**SOILS AND GEOLOGY STUDY
RETREAT AT TIMBERRIDGE FILING NO. 4
PARCEL NO. 52220-00-023
EL PASO COUNTY, COLORADO**

Prepared for:
**TimberRidge Development Group, LLC
2138 Flying Horse Club Drive
Colorado Springs, CO 80921**

December 21, 2023
Revised June 17, 2024
Revised August 6, 2024

GEOLOGY / ENGINEERING MAP

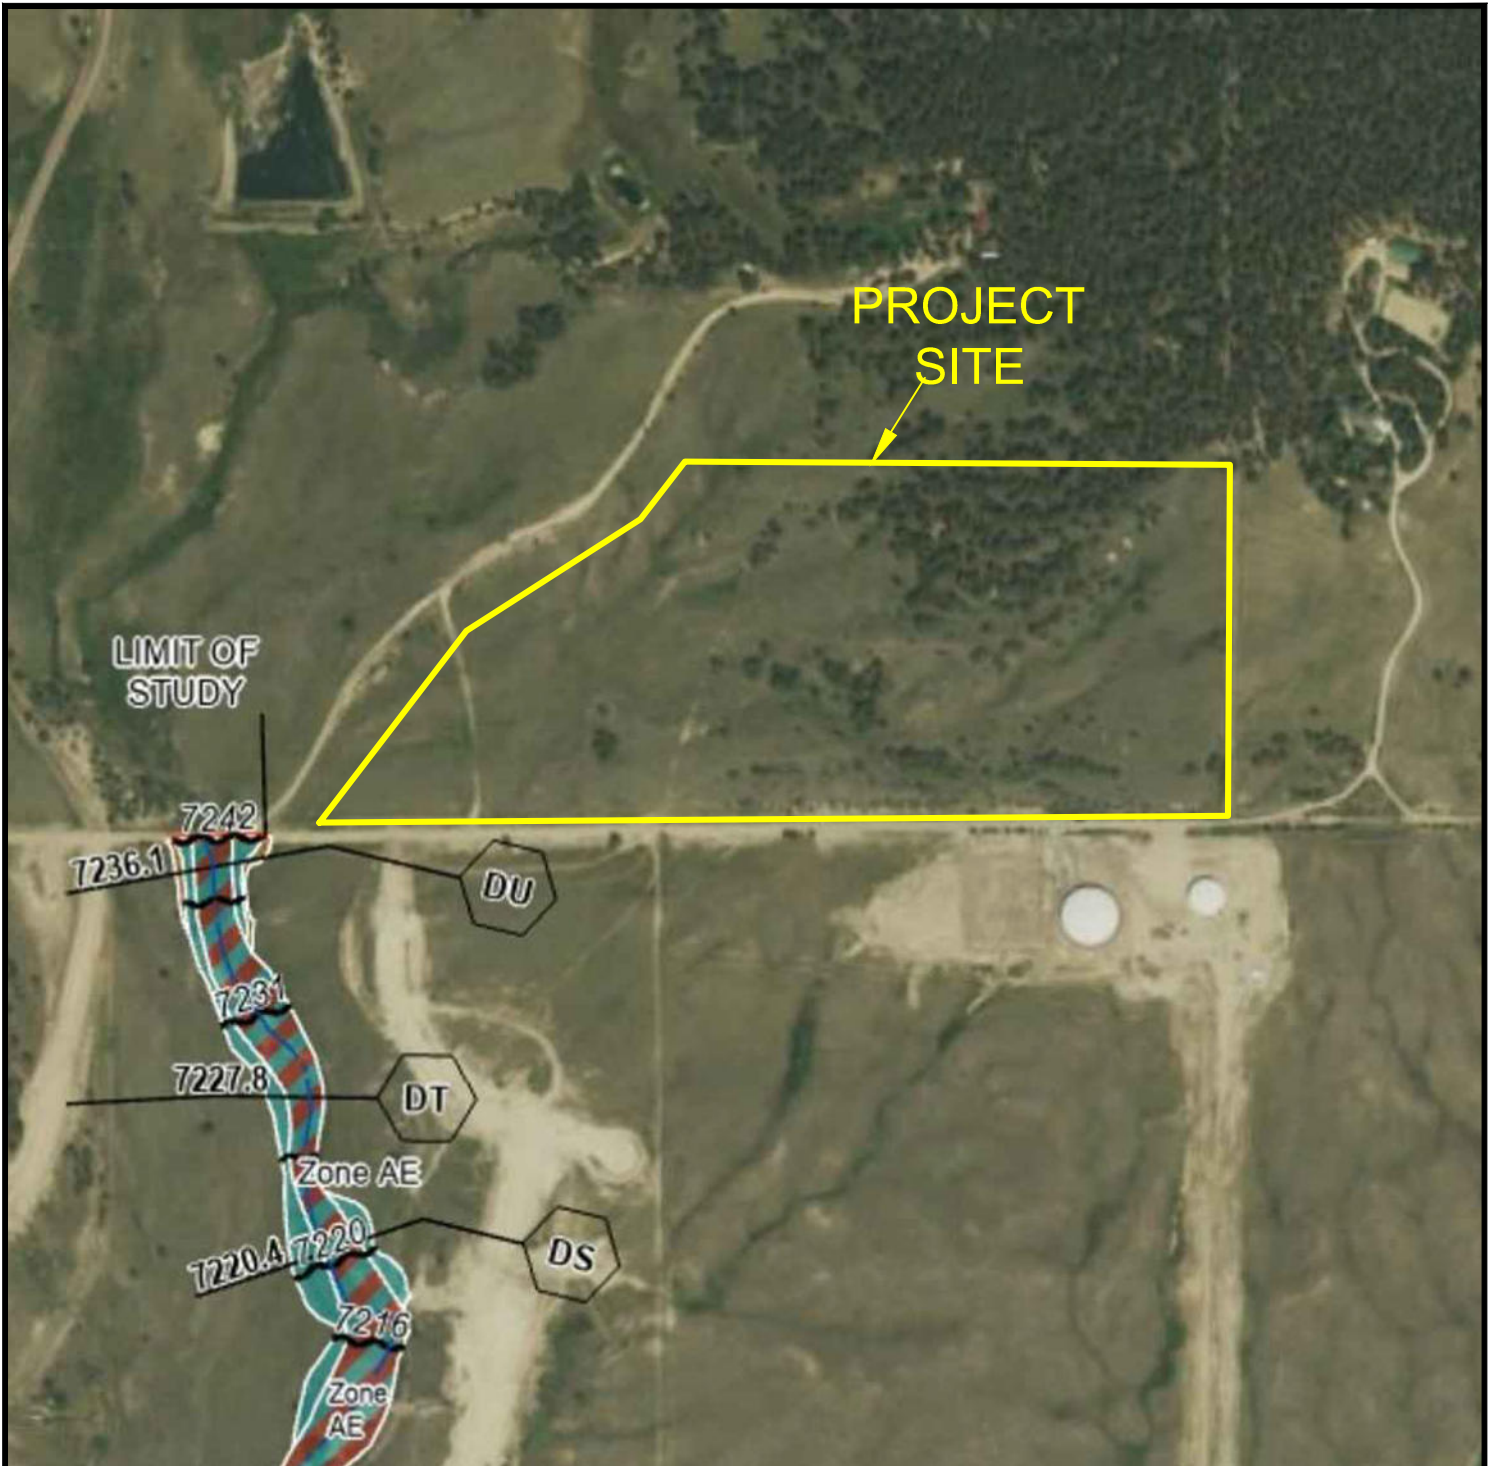
Discuss where the foundation drains will discharge to. Groundwater intercepted should be recharge to the ground and not be conveyed to the Pond or Sand Creek.

Unresolved. See comments from v2, v3: The plans are close to approval and construction will commence once this item on the Soils Report is addressed and the project is accepted so groundwater needs to be addressed at this time. The potential for groundwater issues should be addressed in this report with design recommendations provided and incorporated into the proposed design.

Unresolved. See comments from v2, v3: The plans are close to approval and construction will commence once this item on the Soils Report is addressed and the project is accepted so groundwater needs to be addressed at this time. The potential for groundwater issues should be addressed in this report with design recommendations provided and incorporated into the proposed design.

The northern side of the proposed embankment for the Extended Detention Basin (EDB) is located in a potential seasonal shallow groundwater area as indicated on the Geology/Engineering Geology Map, Figure 6. Areas receiving fill may require stabilization with rock or geogrid if shallow groundwater conditions are encountered. A private storm sewer that discharges to the EDB is proposed along a section of Nature Refuge Way and through the drainage easement on Lot 1. **Additional investigation of the pond is recommended as plans are finalized and prior to construction.**

The northern side of the proposed embankment for the EDB is located in a potential seasonal shallow groundwater area as indicated on the Geology/Engineering Geology Map, Figure 6. Based on the soils types and the gradual existing slopes near the EDB location lining of the EDB is not necessary. Any areas to receive fill should have all topsoil, organic material or debris removed. Prior to fill placement Entech should observe the subgrade. Fill must be properly benched and compacted to minimize potentially unstable conditions in slope areas. Fill slopes should be 3:1 or flatter. The subgrade should be scarified and moisture conditioned to within 2% of optimum moisture content and compacted to a minimum of 95% of its maximum Modified Proctor Dry Density, ASTM D-1557, prior to placing new fill. Areas receiving fill may require stabilization with rock or fabric if shallow groundwater conditions are encountered.
